INTERIM UNIVERSITY HOSPITAL & LEVEL I TRAUMA CENTER
 PROJECT NUMBER: 01-107-05B-13, Part GB
 STATE ID: 1-36-069 STATE ID NO.: 09923

MARK	DATE	DESCRIPTION
DRAWING ISSUED:	2/11/08	
PROJECT NO:	0580-F	
DRAWING TITLE:	FLOOR 1 LIGHTING PLAN	
DRAWING NUMBER:	E201	
	SHEET 174 OF 234

PACKAGE
F
 UMOB, ELEV. TOWER, GARAGE DEMO, IH LAB / UMOB ROOFS + FUEL TANKS

MARK	DATE	DESCRIPTION
	2/17/08	DRAWING ISSUED
		PROJECT NO: 0580-F
		DRAWING TITLE: BRIDGE ELECTRICAL DEMO, LIGHTING, POWER & SYSTEMS PLANS
		DRAWING NUMBER: E209
		SHEET 182 OF 234

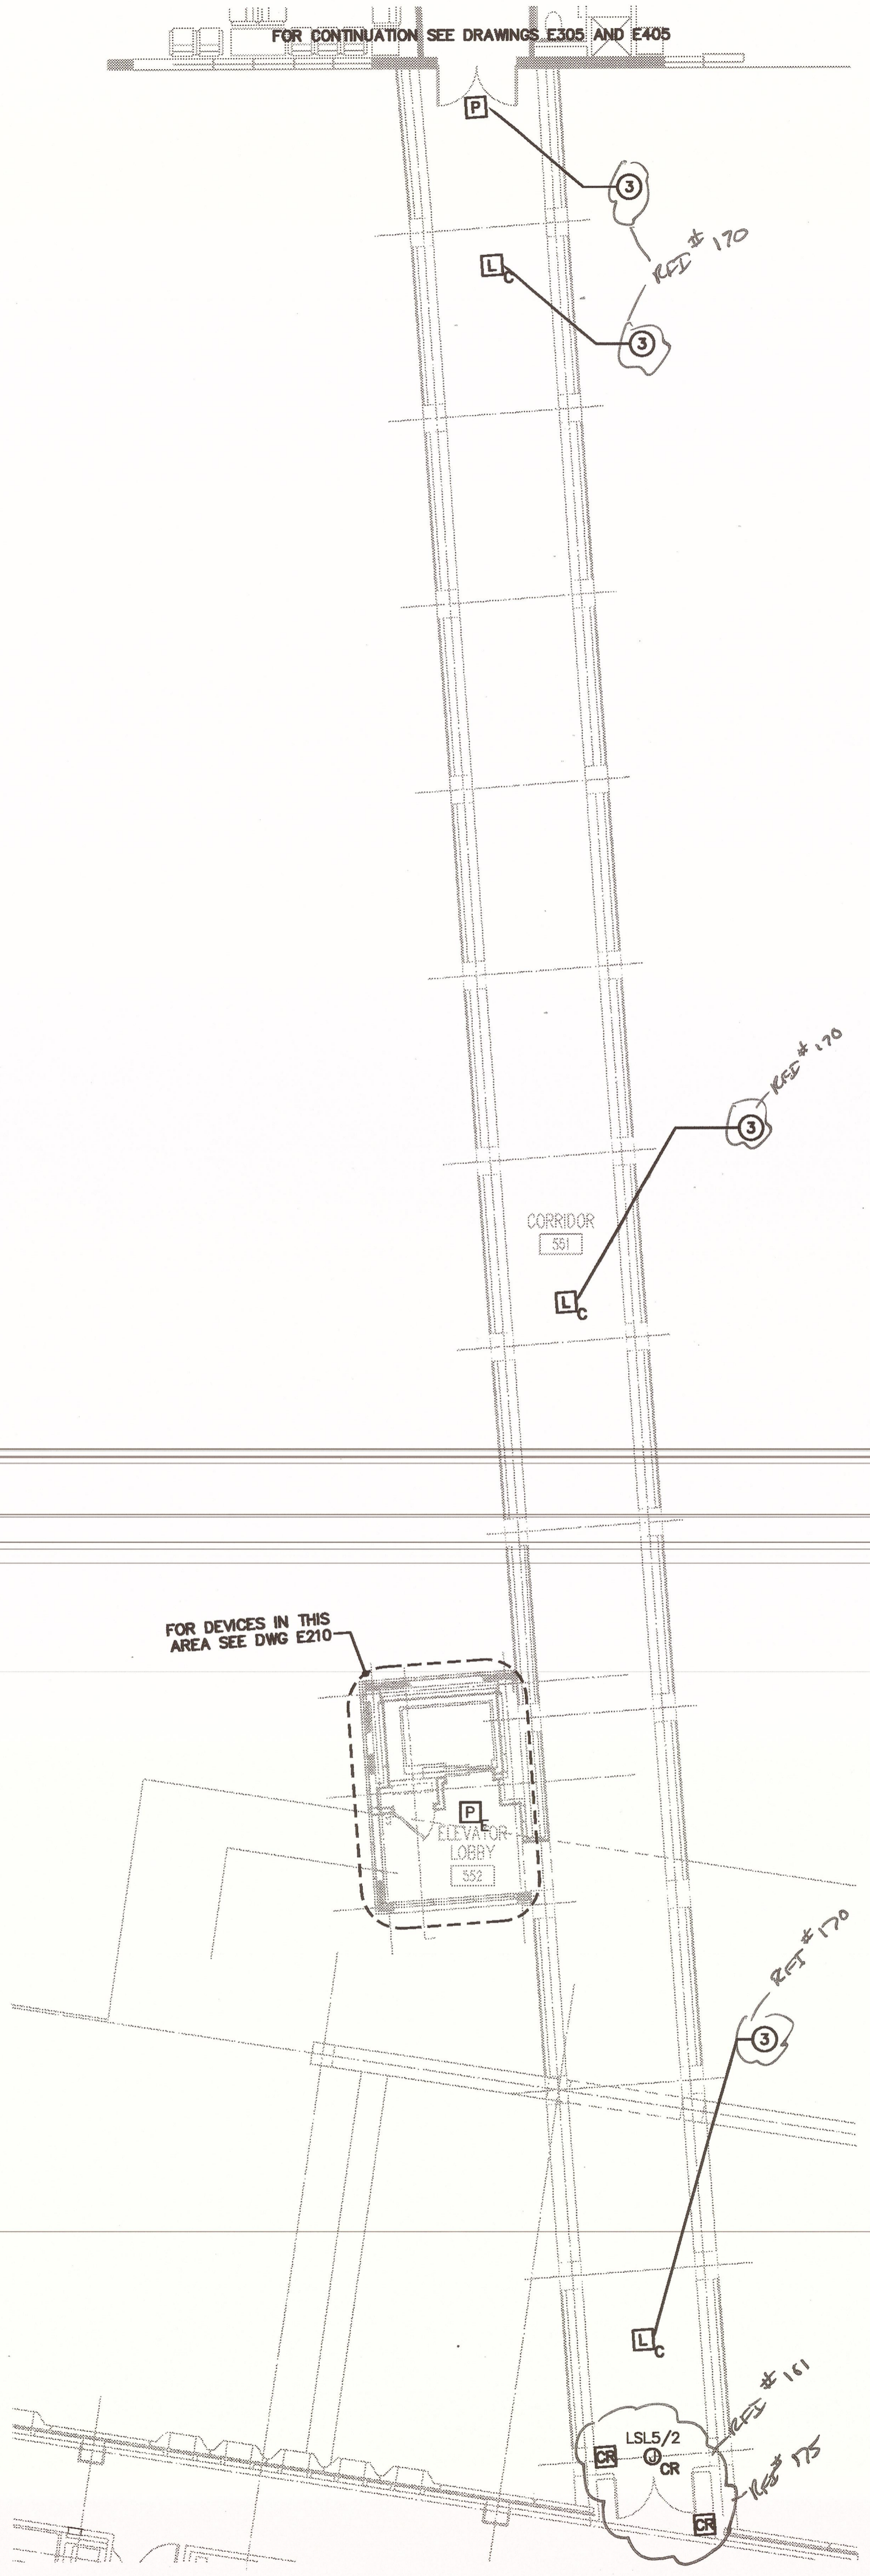
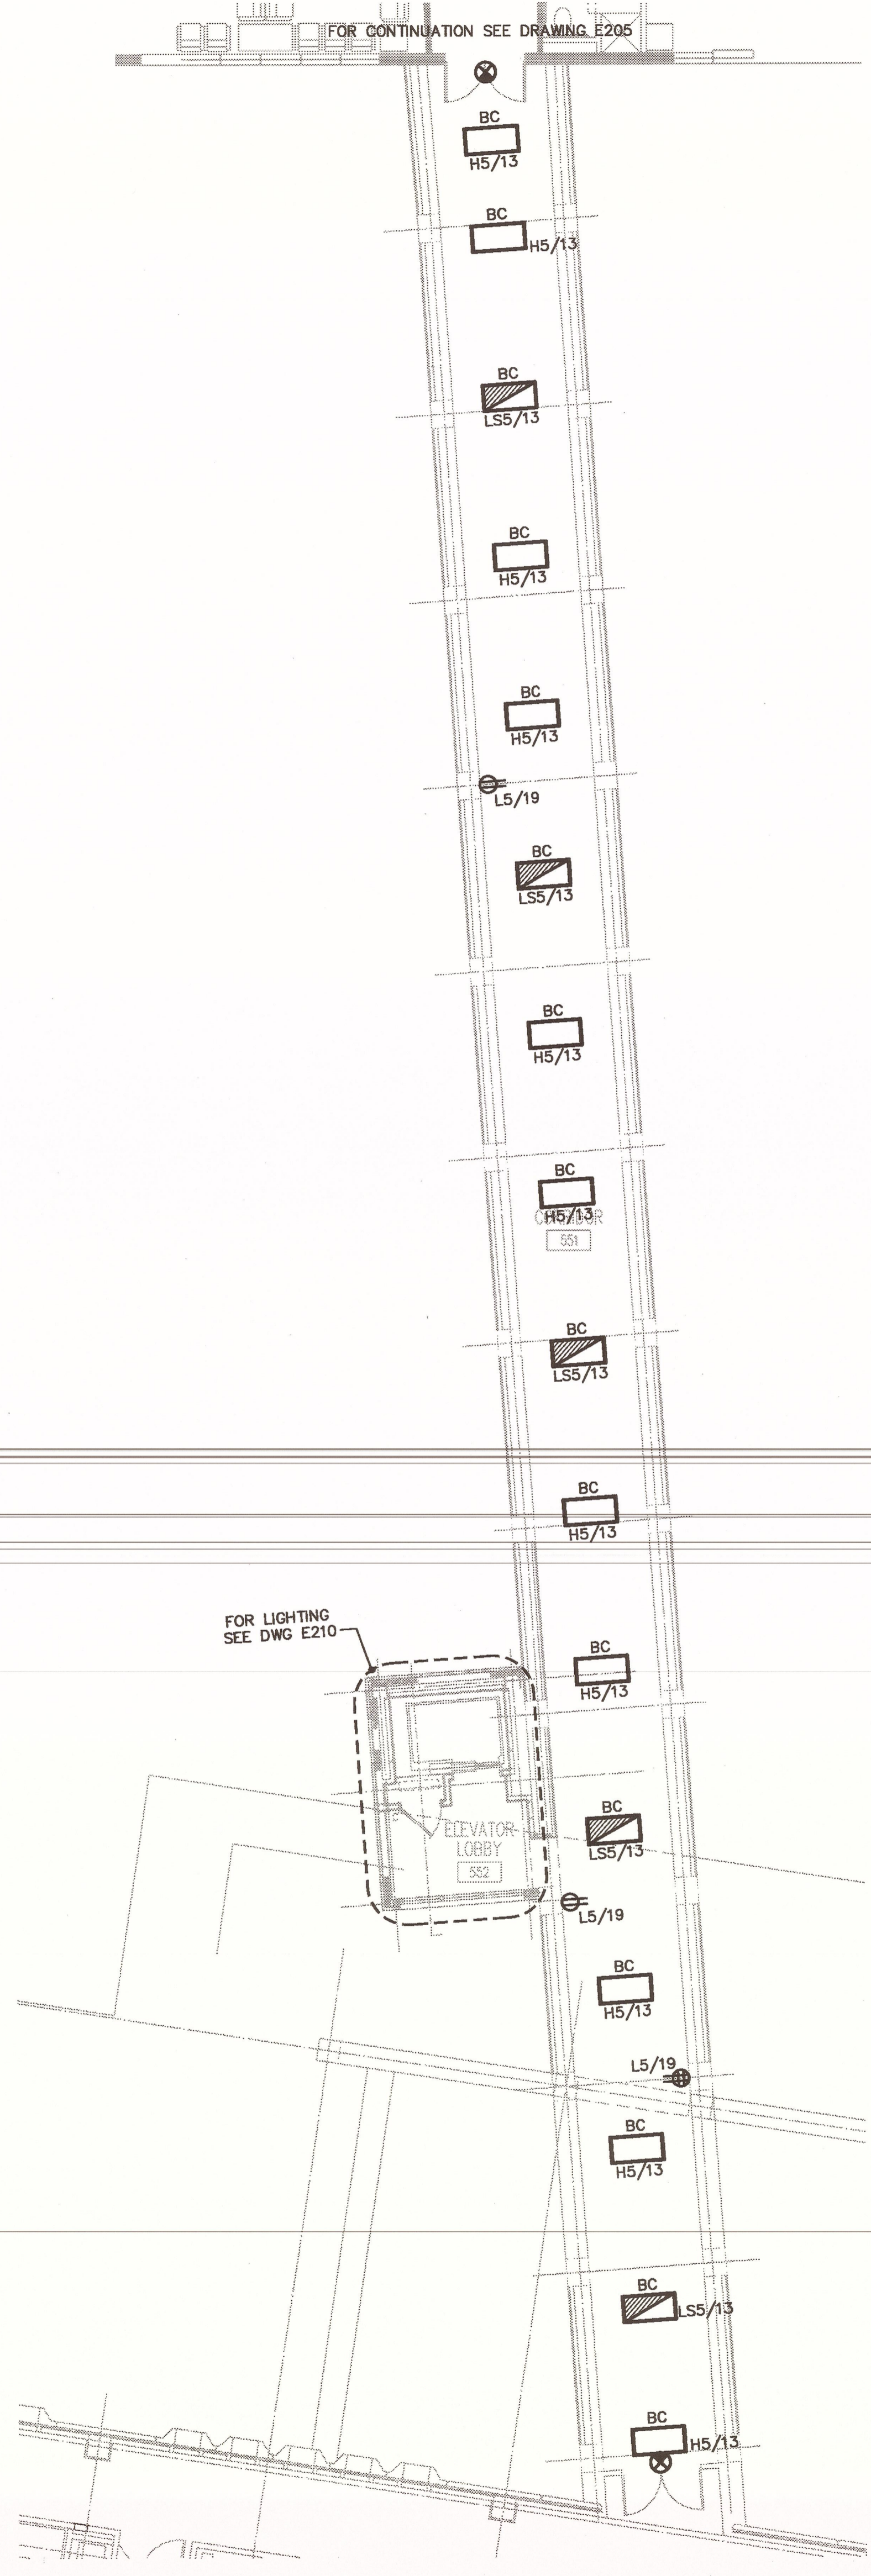
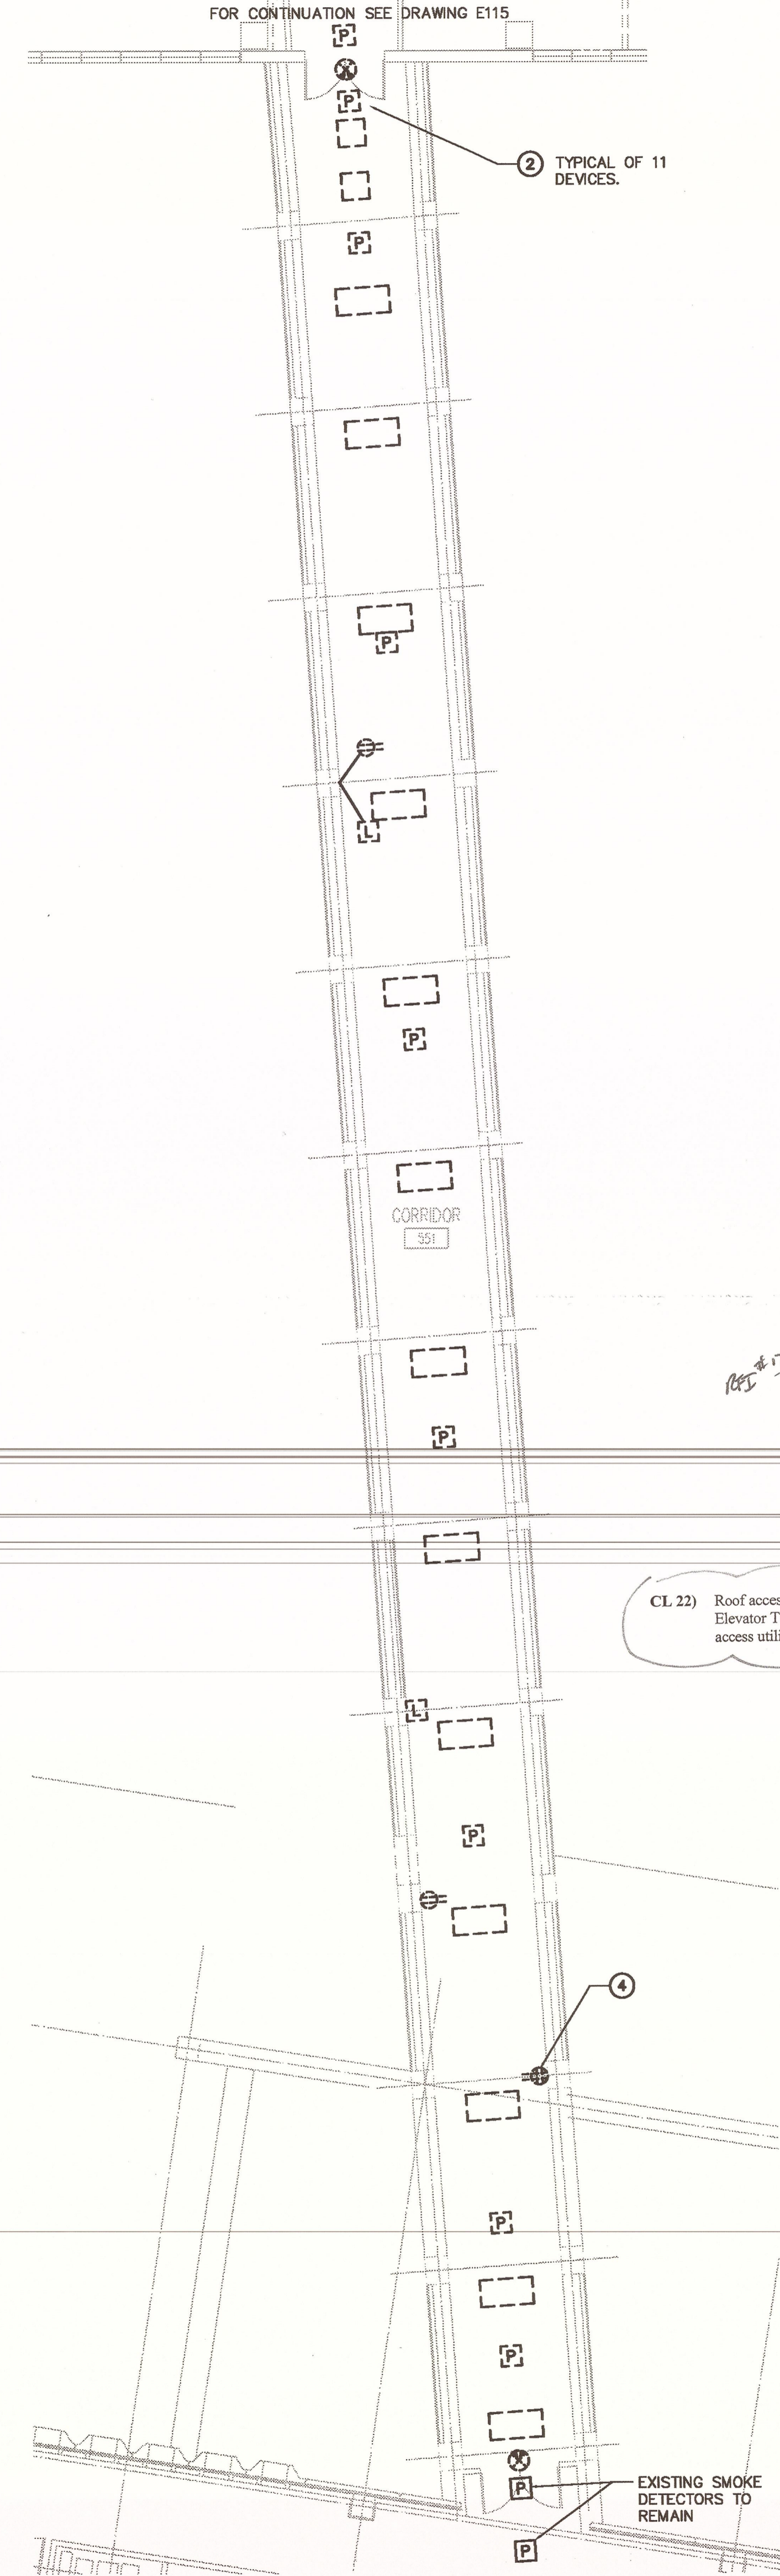
CL 22) Roof access to the 4th Floor Lab roof shall be via the front (north) side of the 1st Floor roof, adjacent to the Elevator Tower. No staging will be allowed in the loading dock drive. The 1st Floor roof or any other means of access utilizing existing building components shall be protected to avoid damage.
